Announcement of Design Change for DG4V-3 Series (REVISED)

- Design change of the DG4V-3 series solenoid operated directional control valves, due to the update of the body's mold cast.
- The new design number is "56".

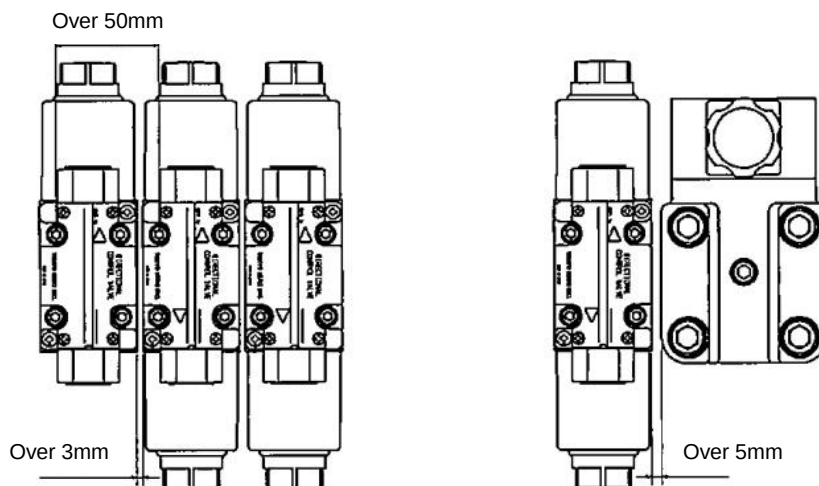
- The previous 54 design models had a 6-side surface treatment. The new 56 design series will have a 4-side surface treatment, leaving the remaining 2 sides with a casting surface.

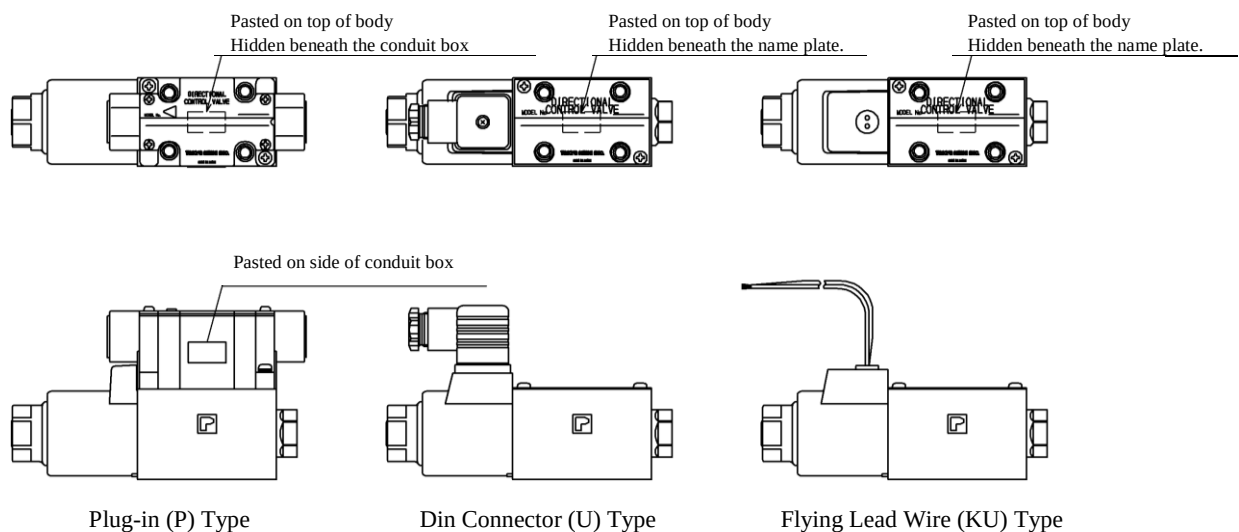
- This change will result in the body having tolerance of ± 1 mm against the designed width (47mm). Please take into account the clearance when setting up valves closely together (please refer to drawing)

When installing DG4V-3 horizontally.

When installing horizontally with other valves

(TGM-3 Series stacking valves may be stacked)
